RS3™

Software Release Notes

Performance Series 1, Release 4.2

February 2002
U.S. Manual PN: 12P23600102

Figure 4.4.27. Generating a Report Based on Time

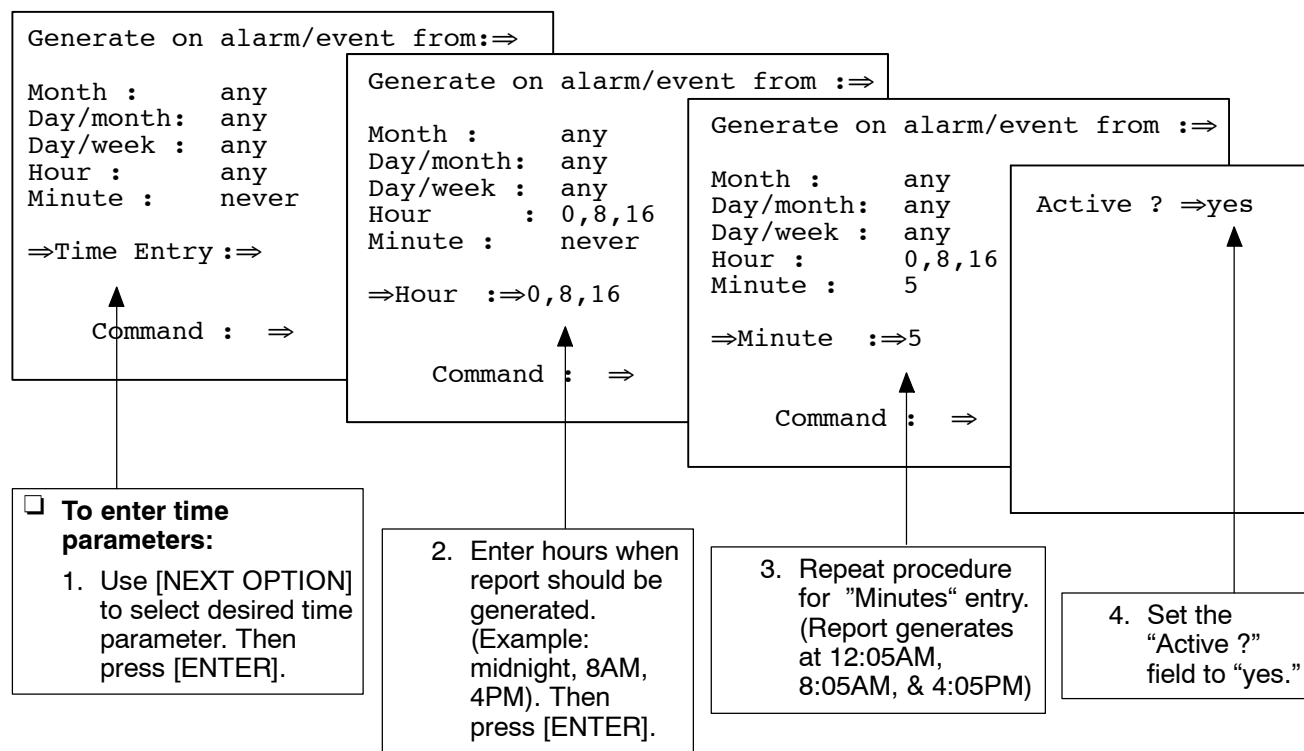
Description: The following sentence was added at the end of the first paragraph under the heading “How to Generate a Report Based on Time and Date” and Figure 4.4.27 was modified to include an additional step on setting the “Active ?” field on page 4-4-38.

Reports configured to print based on time must have the “Active ?” field in the Report Configuration screen set to “yes.”

Figure 1.1.3. ControlBlock Addressing

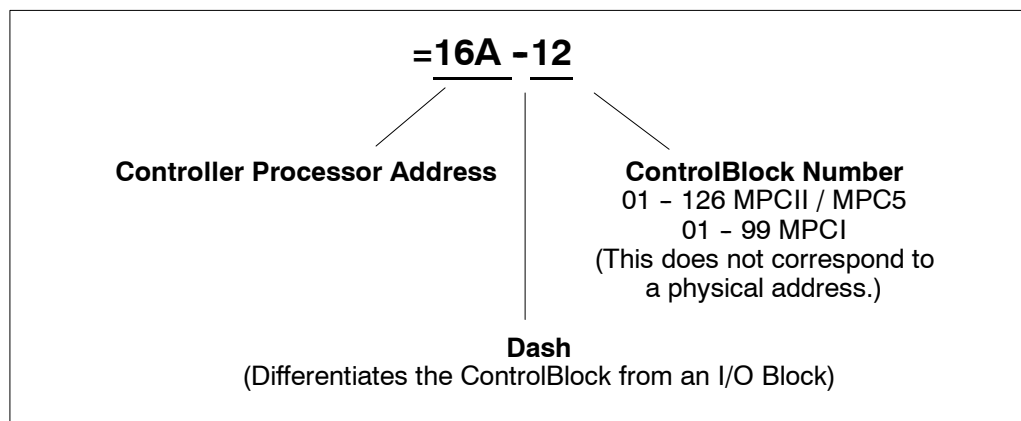
Description: The first bulleted item and Figure 1.1.3 on page 1-1-4 were modified to include the MPC5.

- Up to 126 blocks for an MPCII or an MPC5

Figure 1.3.1. Disk Activity Screen Common Fields

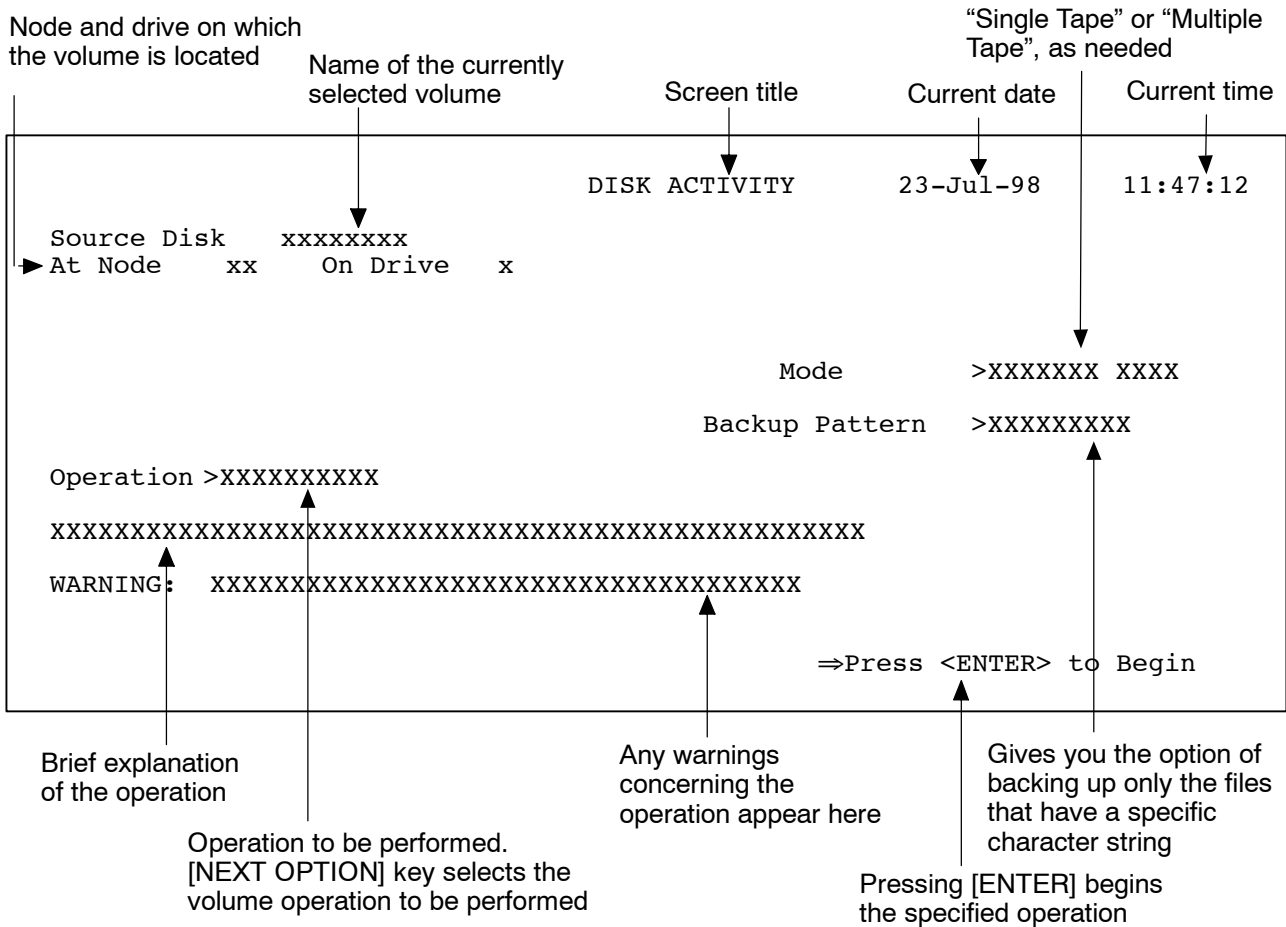
Description: Information on the “Mode” and “Backup Pattern” fields was added to Figure 1-3-1 on page 1-3-1.

Figure 2.4.2 Disk Activity Screen: Disk Controller Save or Backup

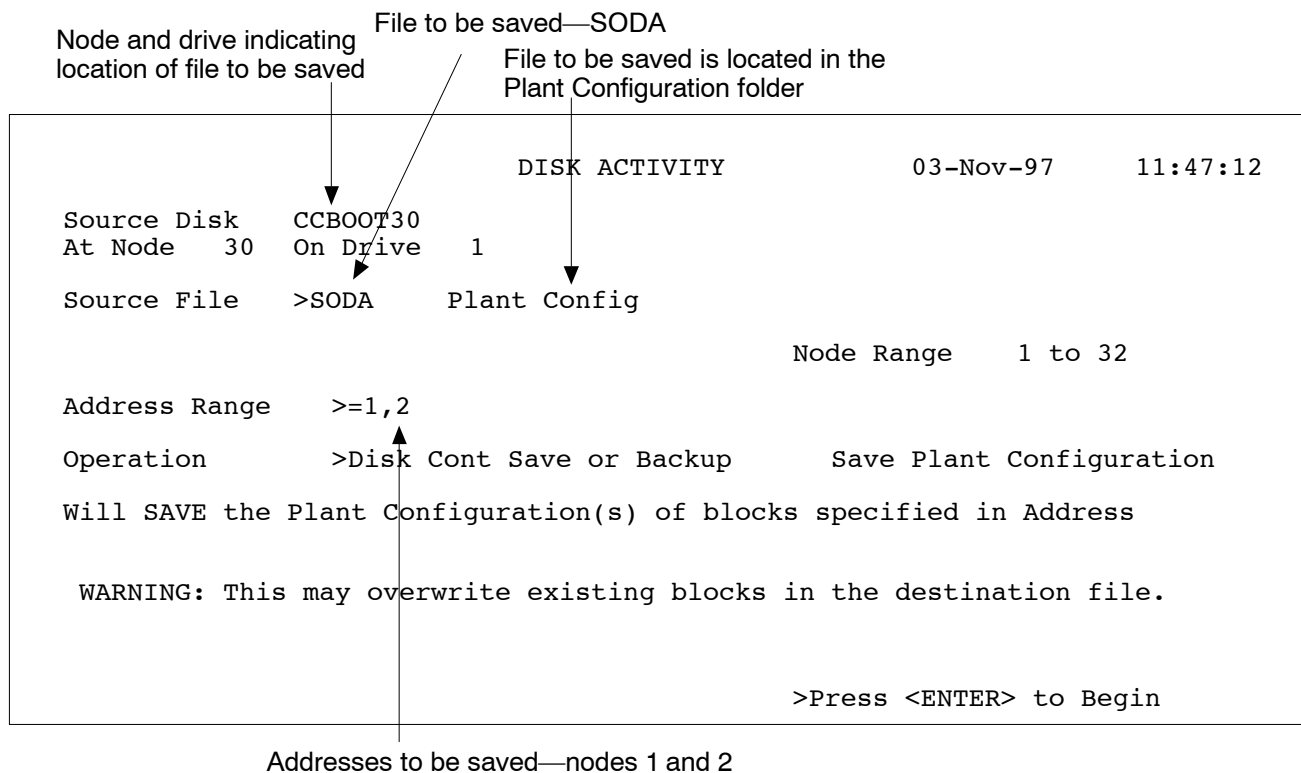
DT-2: Page 2-4-7, Figure 2.4.2 (Disk Activity Screen: Disk Controller Save or Backup)

- Address Range
- Operation
- Will SAVE ...

Replace the existing figure with the modified figure as shown following.

Figure 3.2.11. Configuring a PIOB to Count Pulse Inputs—Target Count Supplied by a ControlBlock

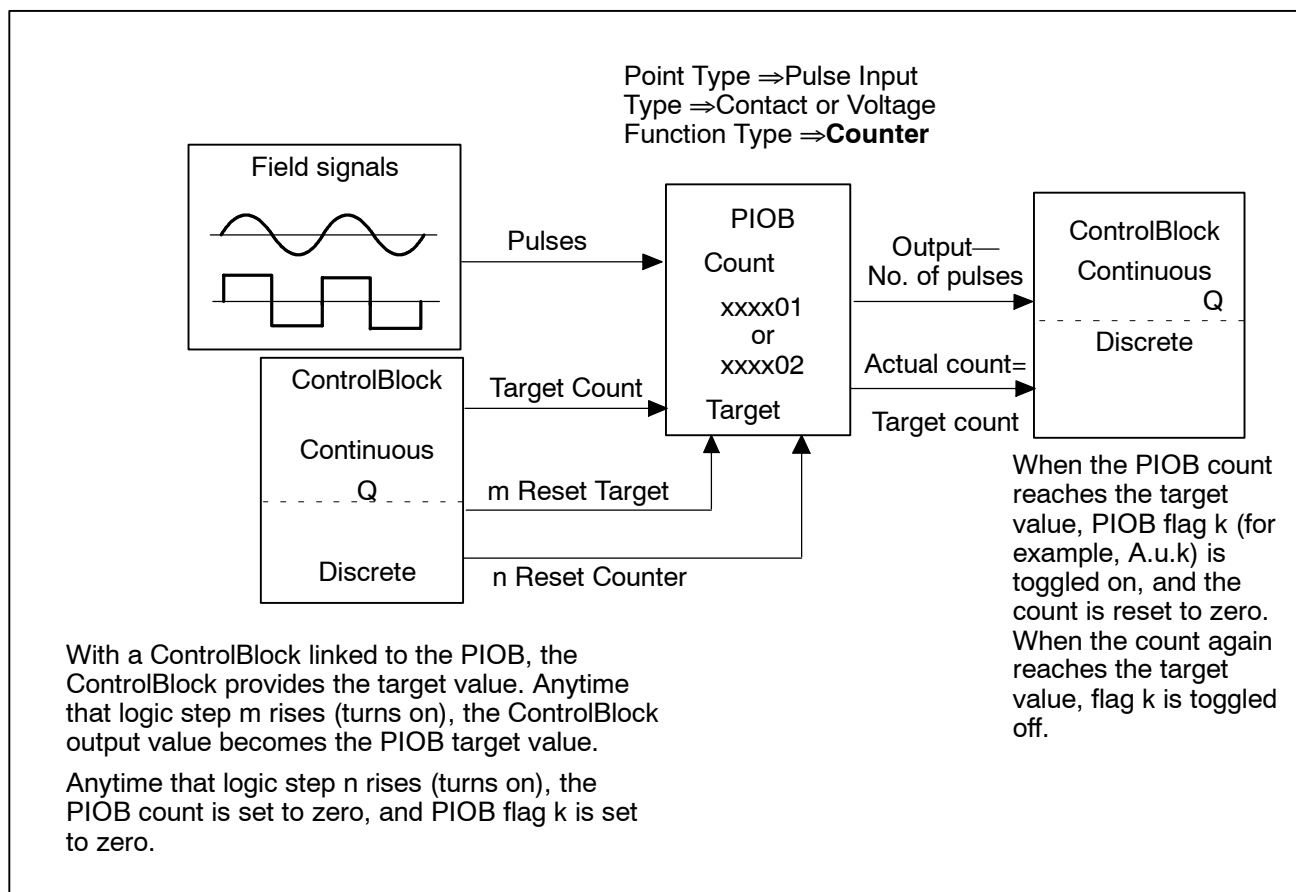
Description: Two notes were added after the first paragraph of the subsection “Target Count Provided by a ControlBlock” on page 3-2-13. Figure 3.2.11 was also modified to give more information on target count supplied by a ControlBlock.

NOTE: Make sure that the source block high limit for the target count is above the maximum count.

NOTE: The “Source HF” field on the PIOB must be set to “no”.

Figure 8.2.2. How an HOB Functions with a Smart FIC or Multipoint Hardware in a Control Loop

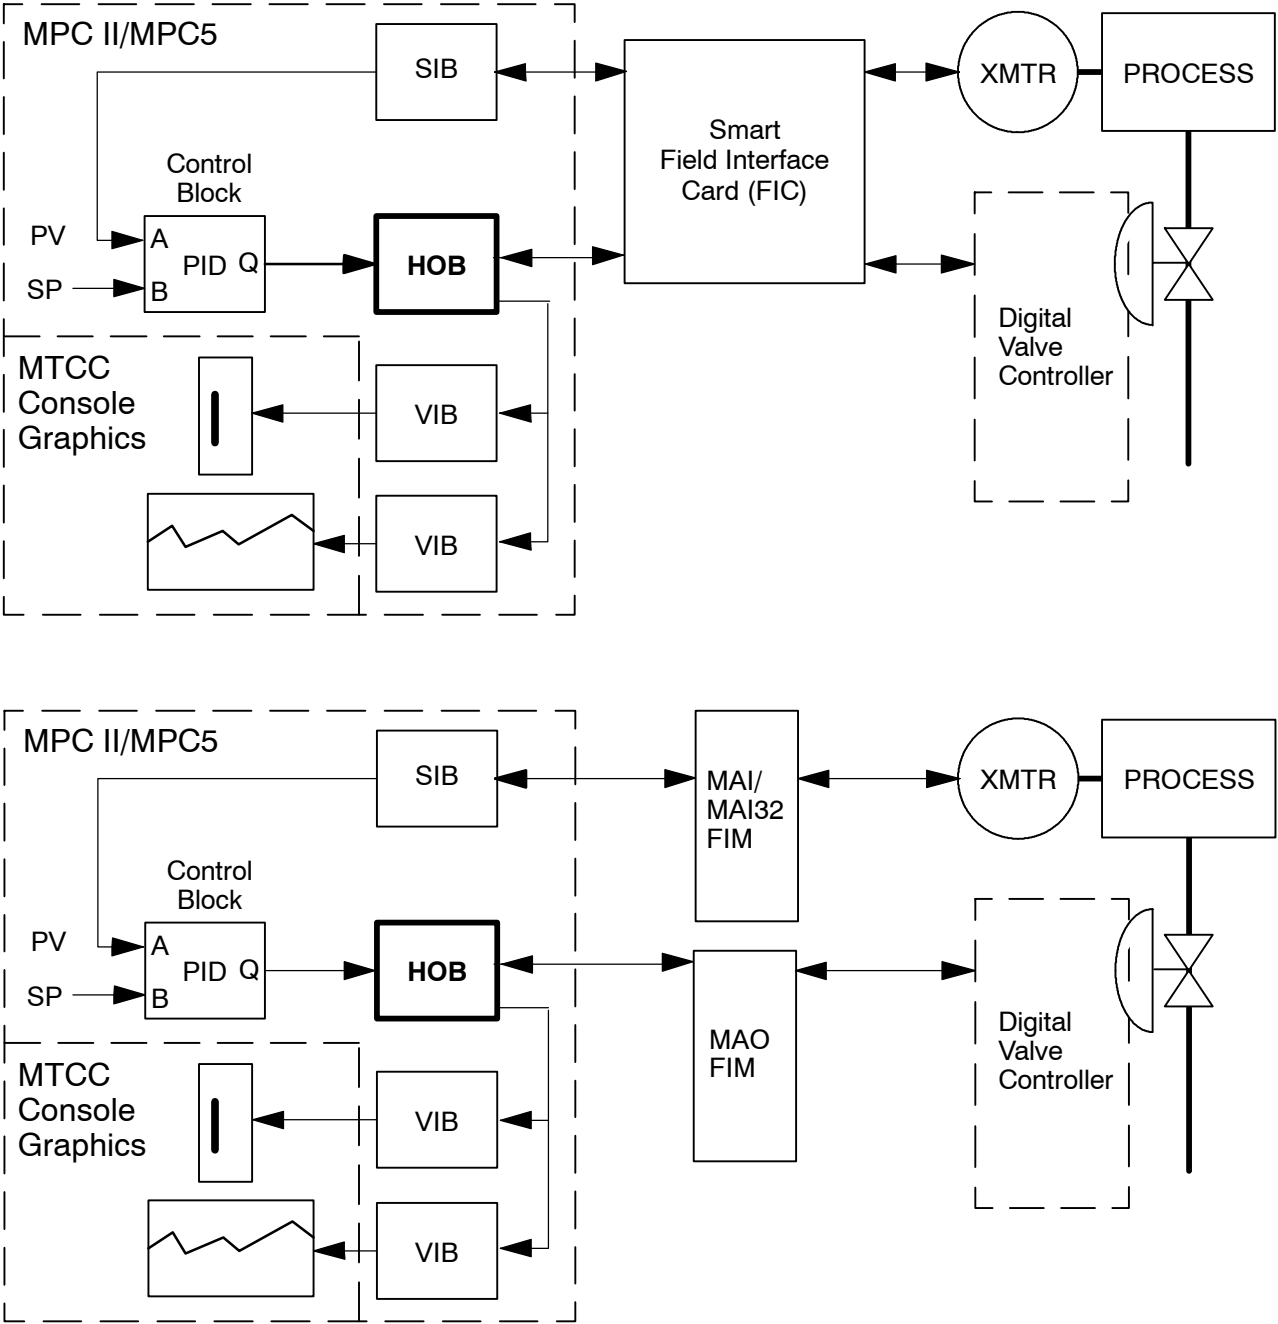
Description: Figure 8.2.2 on page 8-2-3 was modified to include MPC5s.

Figure 9.2.1 PLC Addressing Scheme

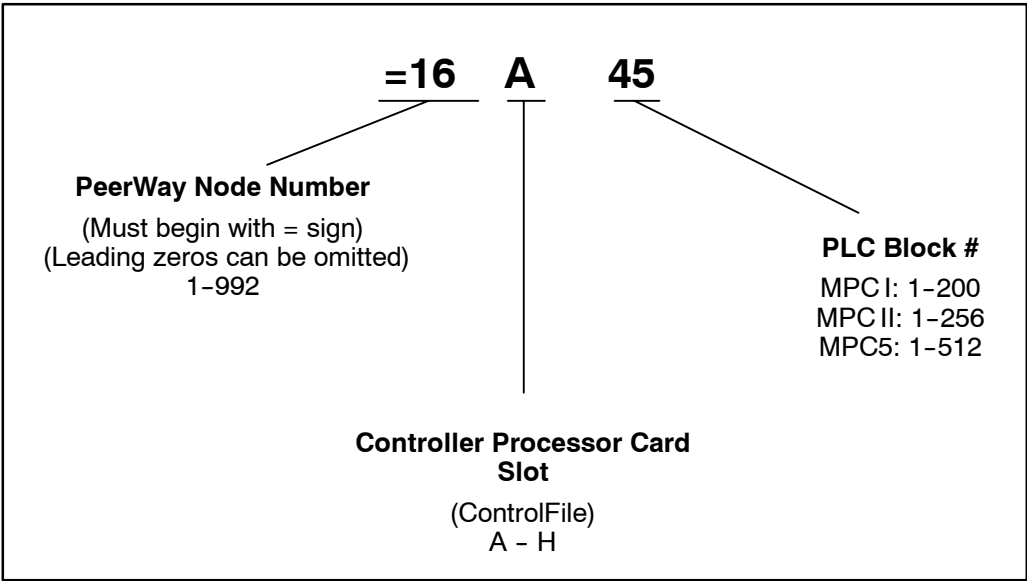
Description: Add the following information to the second paragraph and change Figure 9.2.1 under this topic (page 9-2-4).

For an MPC5, the maximum number of blocks per controller is 512.

Figure 9.3.12 PLCB I/O Block Configuration Screen (Data Type Other Than Flags)

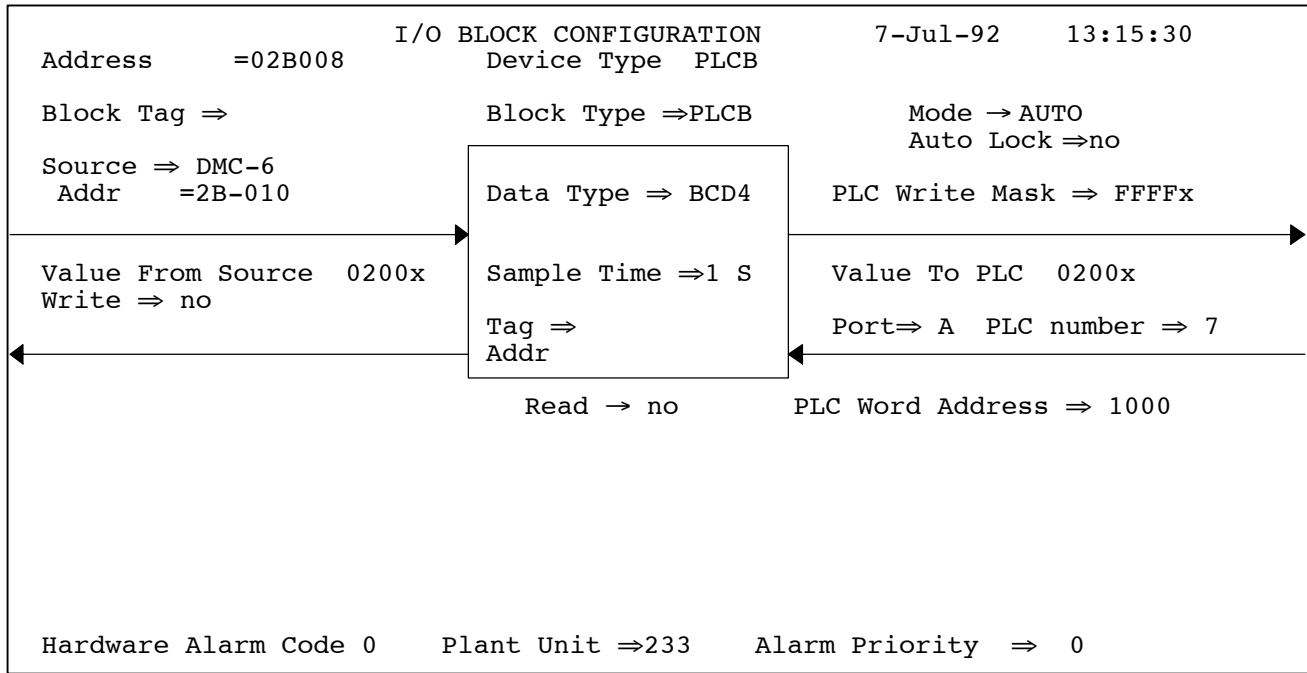
Description: Changes to Table 9.3.11 are a result of additional data type fields and Figure 9.3.12 was modified under this topic (page 9-3-24).

Figure 9.3.13. Using the Write Mask

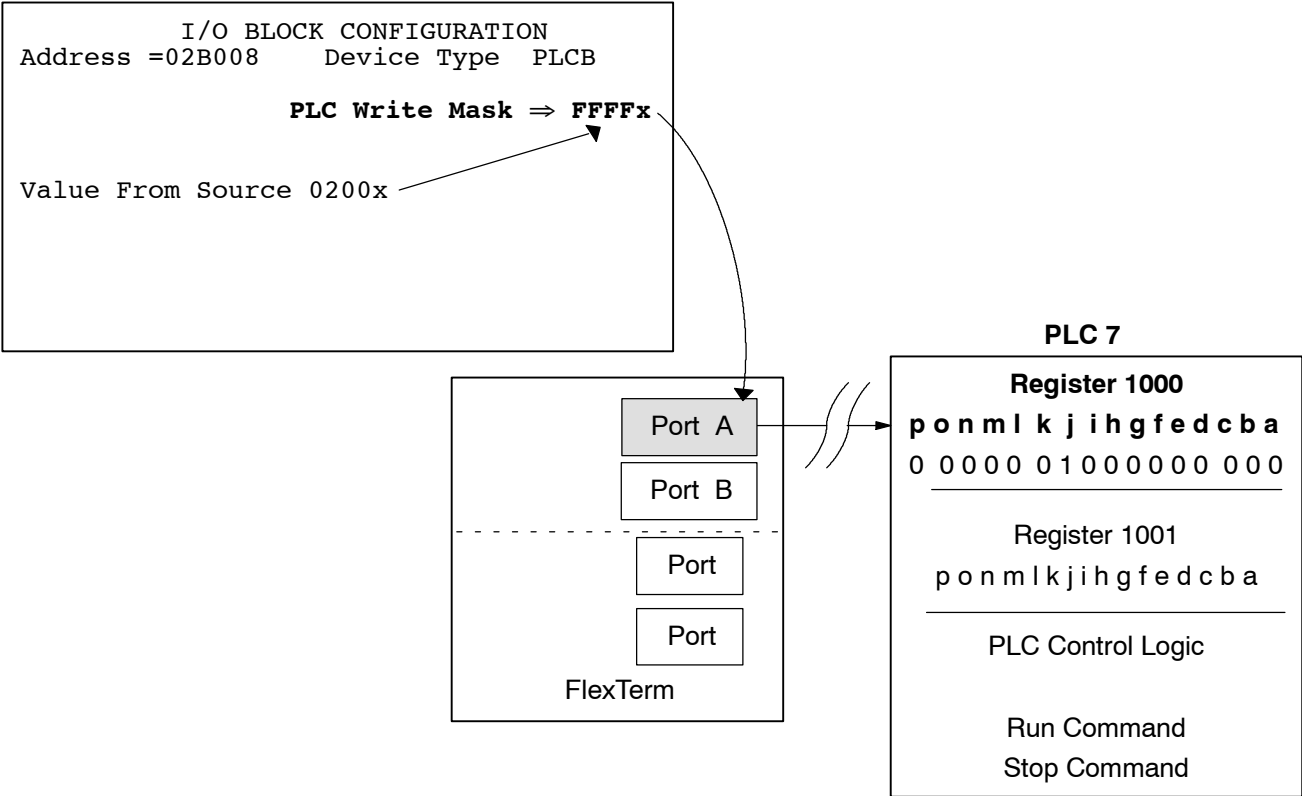
Description: Changes were made to Figure 9.3.13 under this topic (page 9-3-27).

Figure 3.1.2. Single HIA (Front View)

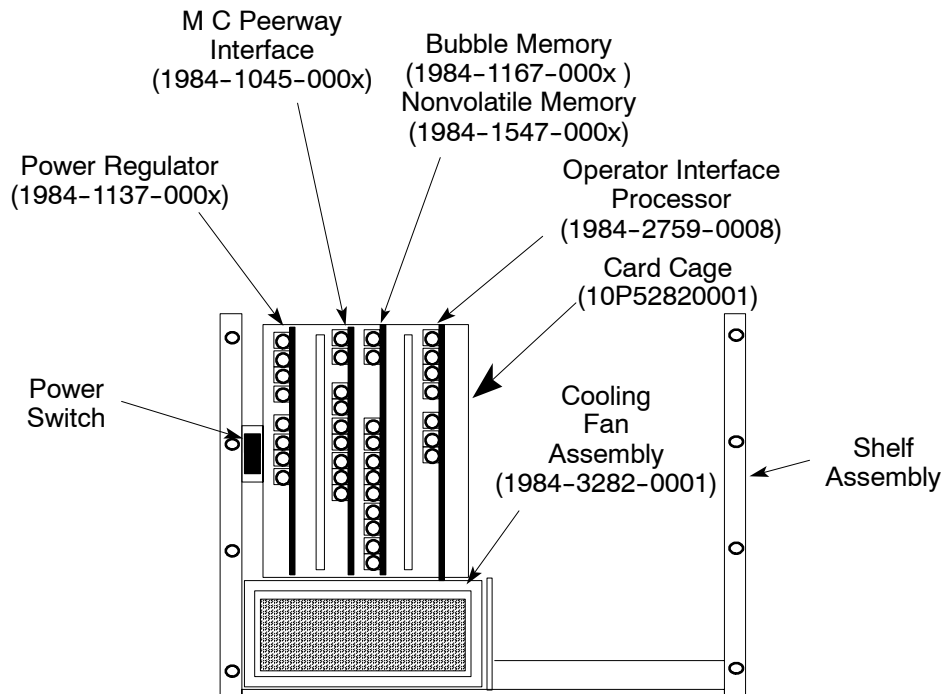
Description: Changes to Figure 3.1.2 on page 3-1-2 and the first paragraph on page 3-1-4 were made to include the part number for the current NV memory card.

The internal/external clock jumpers on the Nonvolatile Memory Card (1984-1167-000x or 1984-1547-000x) determine the source of the HIA clock synchronization. For jumper locations and positioning, see Figure 3.1.4.

Figure 3.9. Typical MIO Cabling

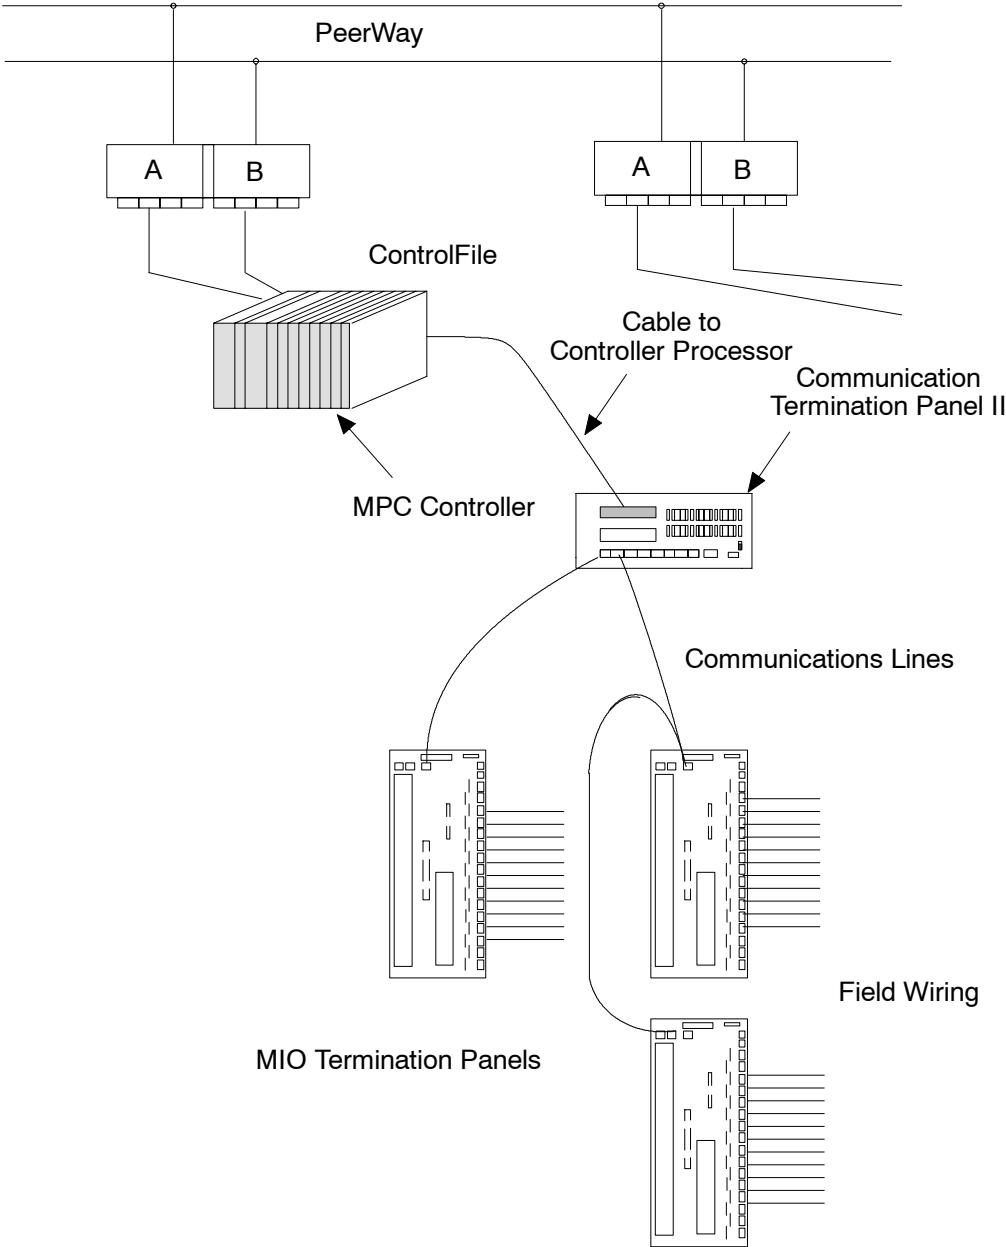
Description: Figure 3.9 was modified to be generic for all controllers (page 3-20).
